# BUILDING REPORTS PTY LTD

27 February 2020

**Re: 6 Wearden Road, Belrose – BCA Report (External Wall)**

**Figure 2 – Part Survey Plan showing setback dimensions to Eastern Boundary**

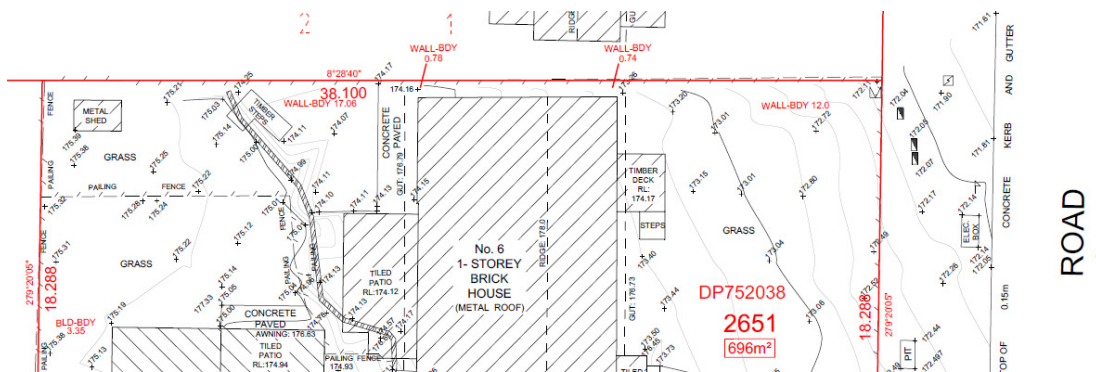
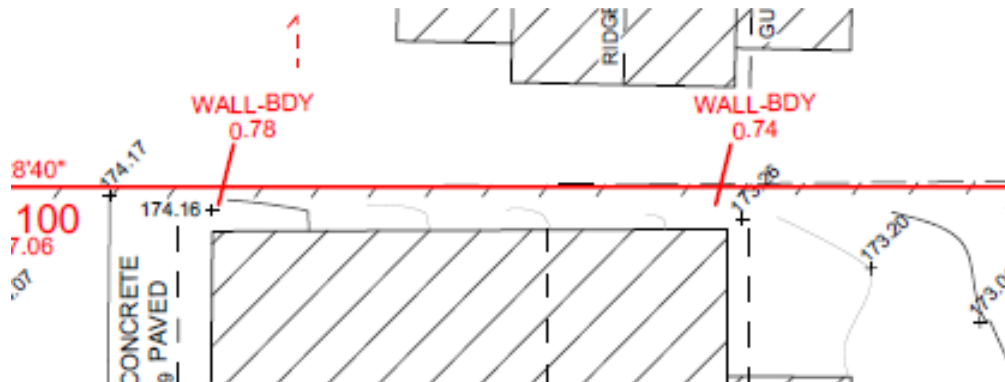
- Less than 900mm from adjacent eastern side boundaries as shown in Figures 1 and 2 below.

- a) The entire eastern external wall within 900mm of the eastern side boundary are not provided with an FRL of 60/60/60 measured from outside the building. This is required to be upgraded with a tested system such as detailed in Figure 3 of this Report, and
- b) The two (2) windows may remain subject to the wall opening for the bathroom window being not greater than 1.2m<sup>2</sup> and the bedroom window being replaced with a non-openable steel frame wired glass or glass block window not greater than 0.54m<sup>2</sup>, and
- c) The fascia is within 450mm of the side boundary and is of combustible materials and requires upgrading. It is noted the existing eave and top roof flashing are considered to be non-combustible and may remain.

- a) *That the eastern external wall to the dwelling and associated elements be upgraded in accordance with BCA [Volume 2] Clause 3.7.2.4 as follows;*
- (i) *Eastern wall is to be provided with an FRL of 60/60/60 measured from outside the building, and*
